File: A013/21

Minor Variance Application

Property: **134 Factor Street, Kleinburg**

Purpose: Relief from By-law 1-88, as amended, is being requested to permit the construction of a proposed single family dwelling.

SITING AND GRADING PLAN

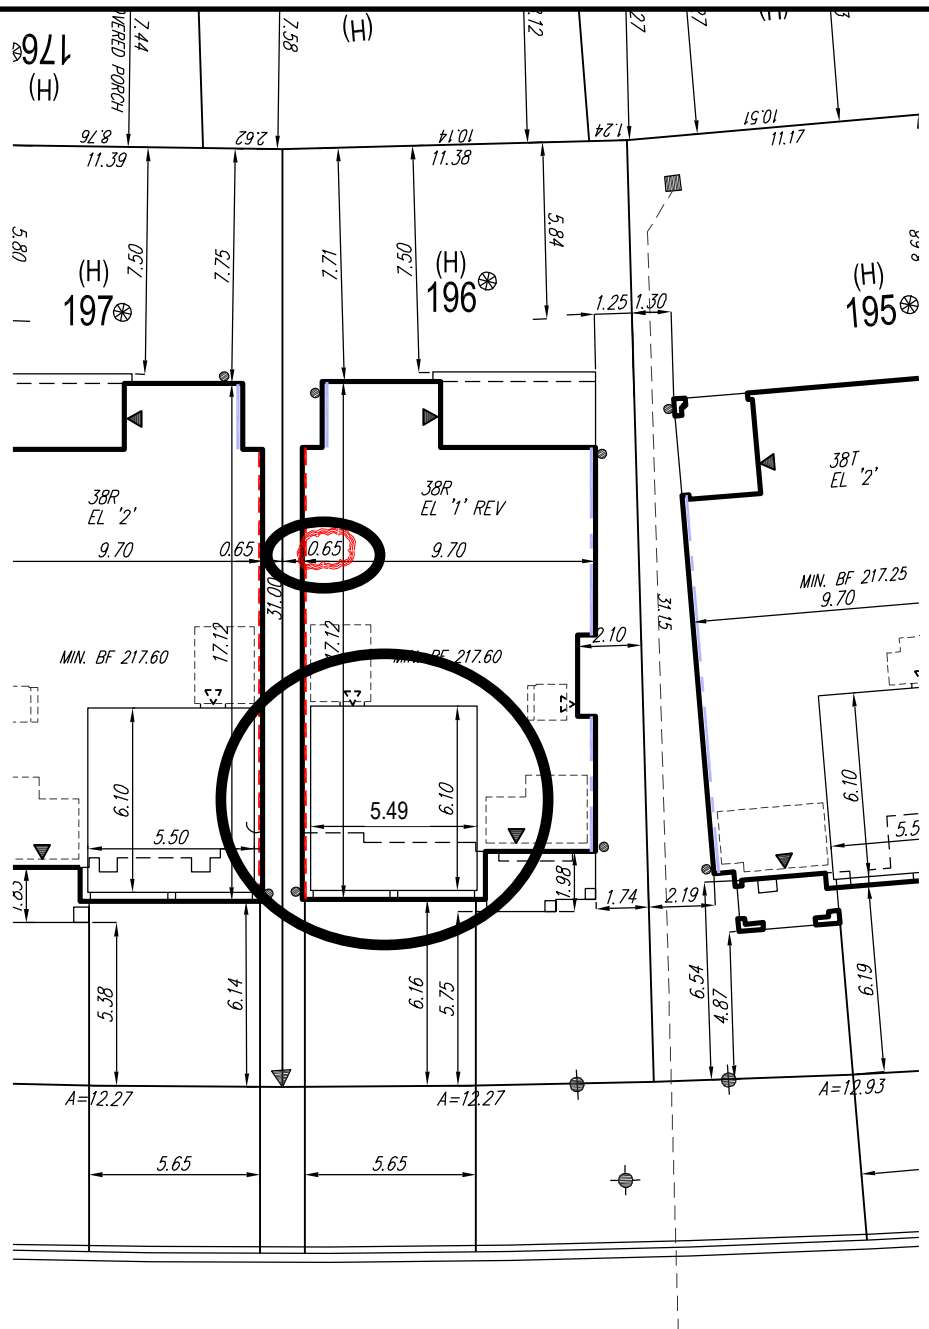
The Owner is requesting permission to construct a garage (attached to a dwelling) with a minimum interior garage dimension of 5.49m (W) by 6.10m (L) and an interior side yard setback of 0.65m. As required by the subdivision agreement and acknowledged by the Owner, maintenance easements will be registered on the interior side yard setbacks that are less than 1.2m.

Please note Development Engineering (DE) Department does not have any objection to permit side yard setback of 0.65m, when the by-law requires 1.2m but may the owner/applicant be aware that the side yard with reduced setback can be used for drainage purpose only, not for anything else.
